**Sandlewood Food Pantry
8 August Lane
Final
Response Letter to Conditions
November 12, 2025
DRB-001075-2025**

Project Narrative for Sandalwood Community Food Pantry

The attached are the responses to DRB's conditions of the approval for DRB-000981-2025

**Sandlewood Food Pantry
8 August Lane
Final Set Plan Set
November 12, 2025
DRB-001075-2025**

SHEET NO. **L.2**

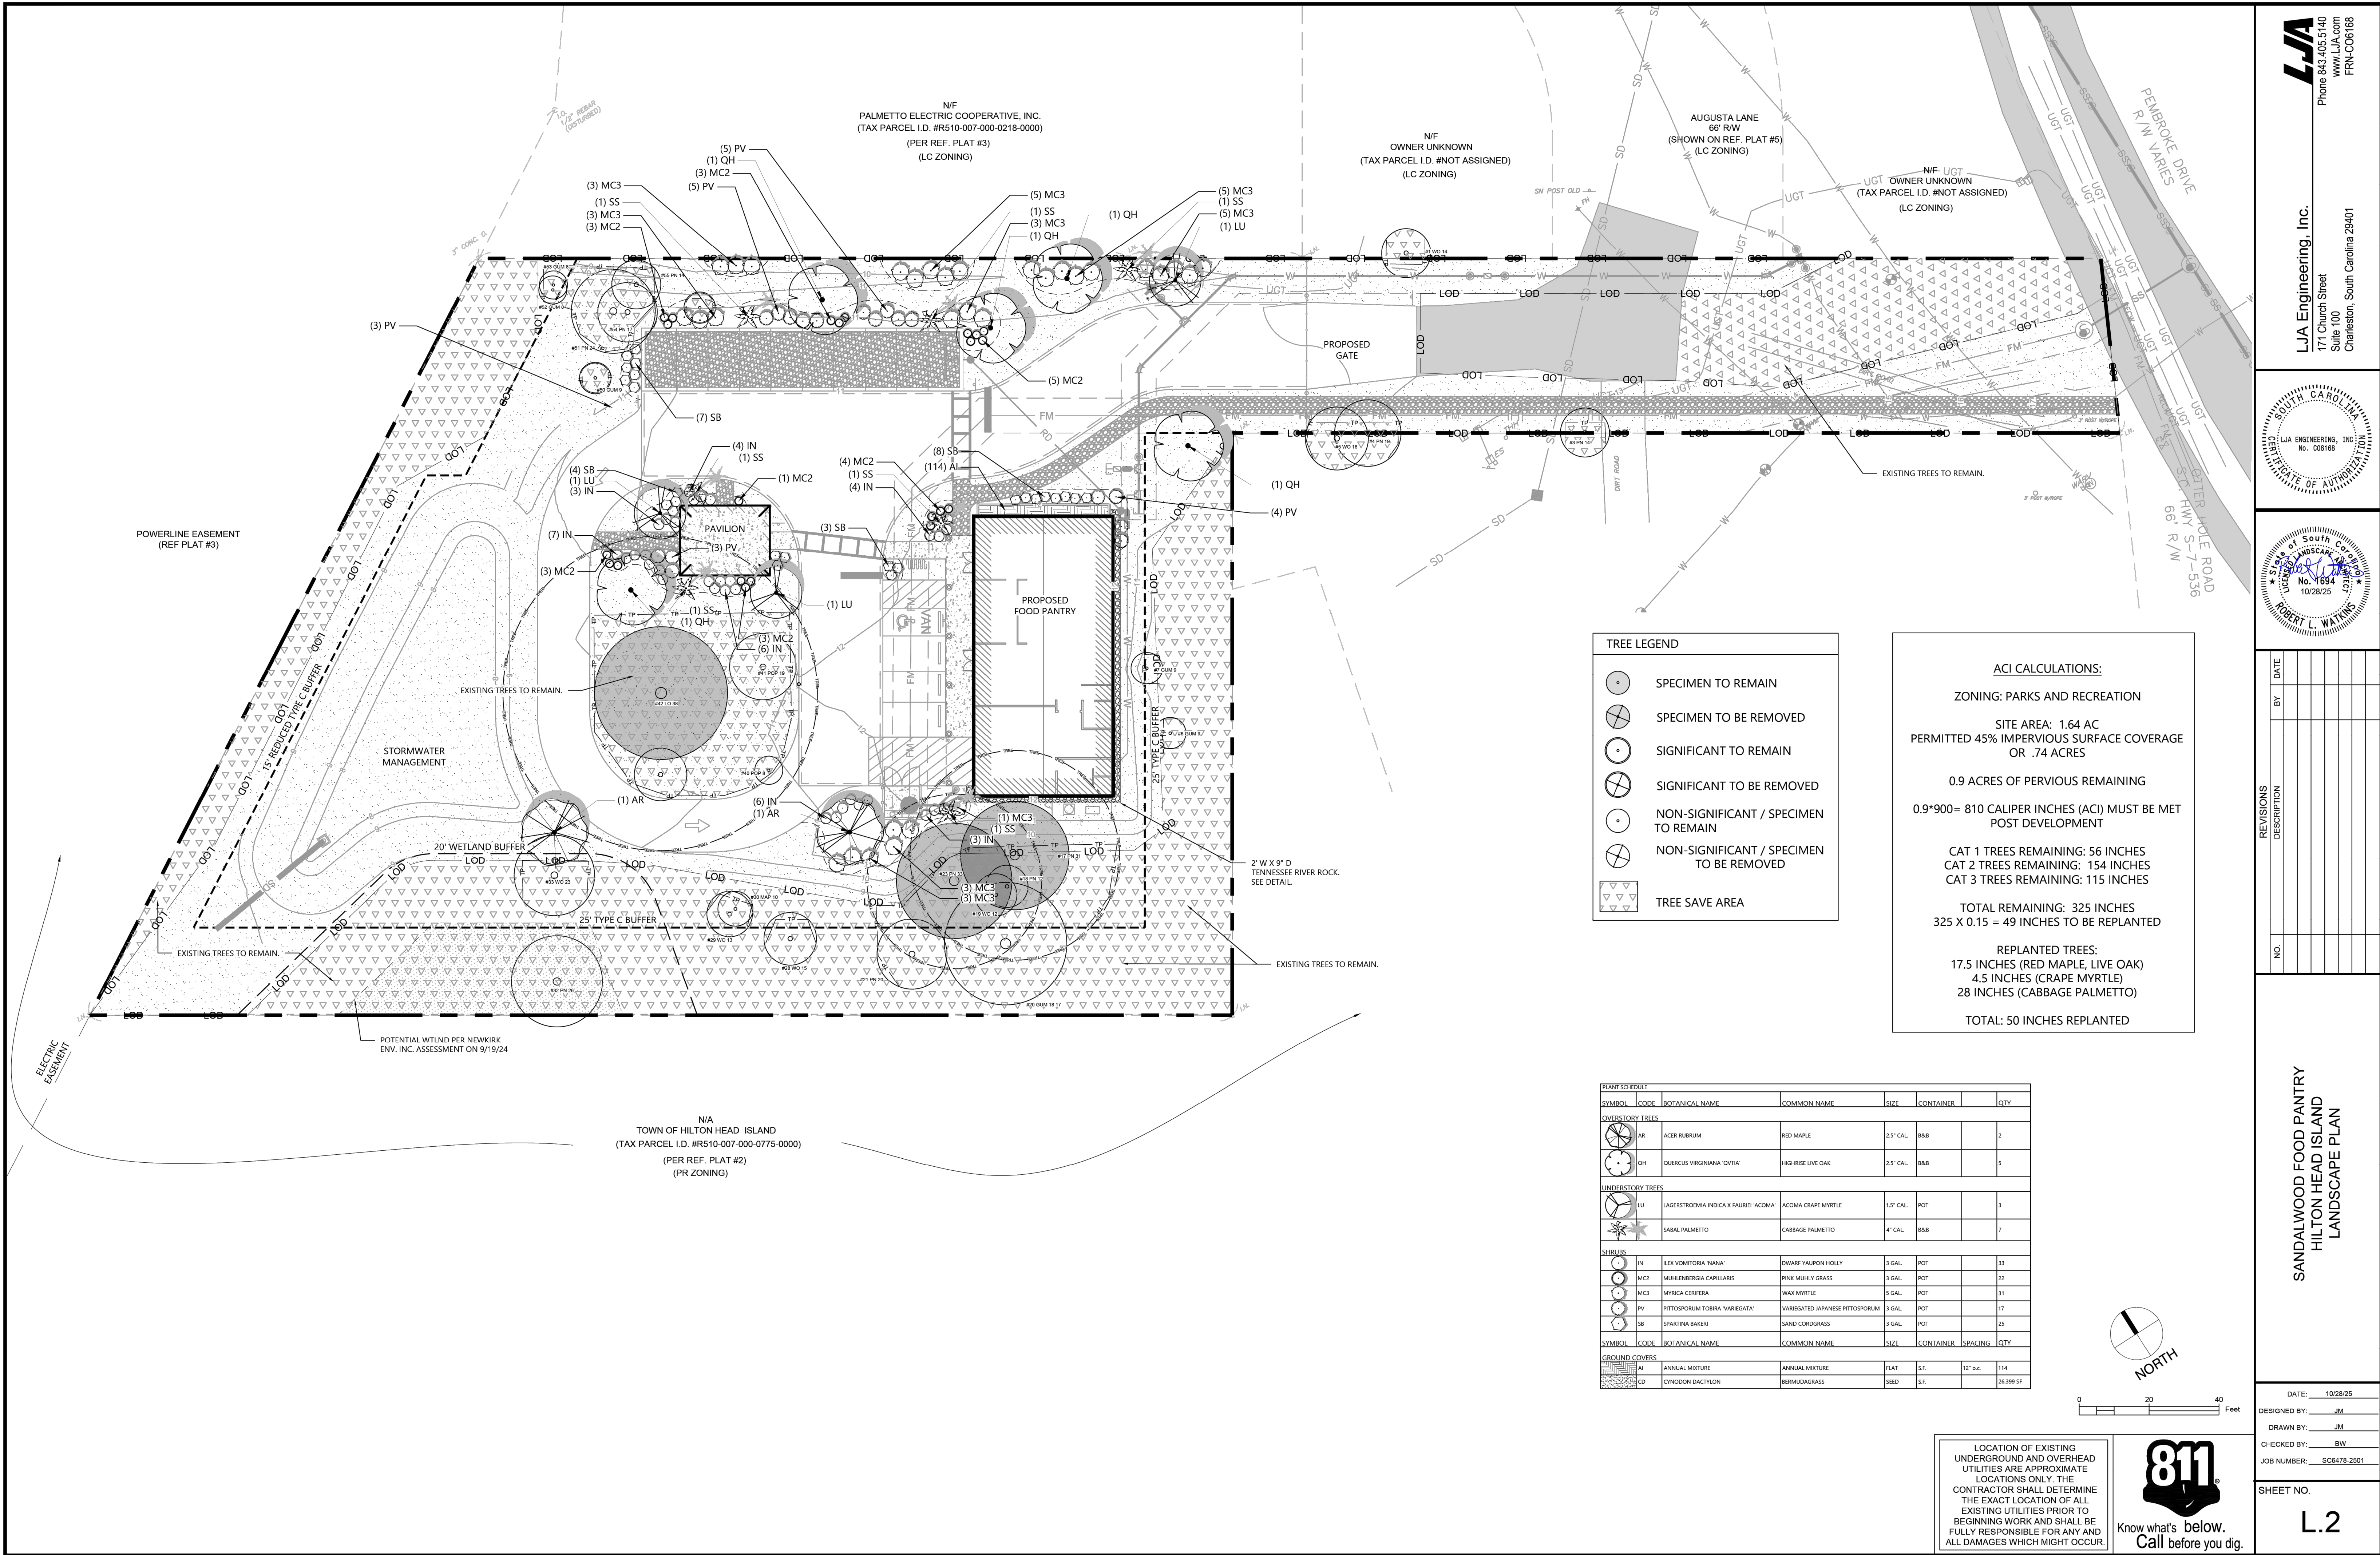
3. Add two additional foundation plantings to the N.E. side of the building. ***More foundation plantings have been added alongside the North East section of the building. This should help screen the entryway and provide an aesthetic view. See sheet L.2 for planting locations.***
